FIRE PREVENTION PLAN

DUST and EMISSION MANAGEMENT PLAN

ODOUR MANAGEMENT PLAN

https://www.metoffice.gov.uk/services/transport/aviation/regulated/airfield-climate-stats#EastMidlands

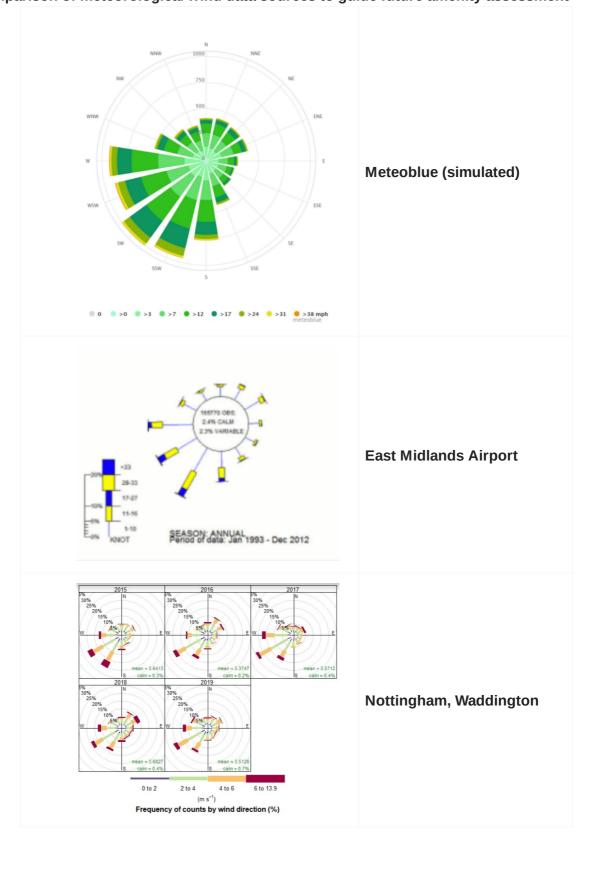
1. Although you have submitted a wind rose data – can you please confirm from which local weather station this data has been taken from?

Please also demonstrate that this is a suitable weather station to use (i.e. that the local geography and topography have a similar resemblance to the waste site and therefore the conditions at the weather station will reflect those of the site) and use it to explain how the weather will affect and how dust will affect local sensitive receptors.

The met office provides data from airport locations so confidence is high. In this case east midlands has been selected. East Midlands can be considered as an urban flat site and therefore has a reasonable degree of consistency with the Colwick location in that the surrounding area is flat and open with developed areas although the meteorological site is more open. The wind rose from East Midlands can be checked for broad consistency with the simulated data.

For the purposes of a wind rose to guide assessment of any dust complaints this is adequate. It would not be appropriate for example if a coastal vs inland site was being compared or a weather station which was being influenced entirely by local topography e.g. a valley or canyon.
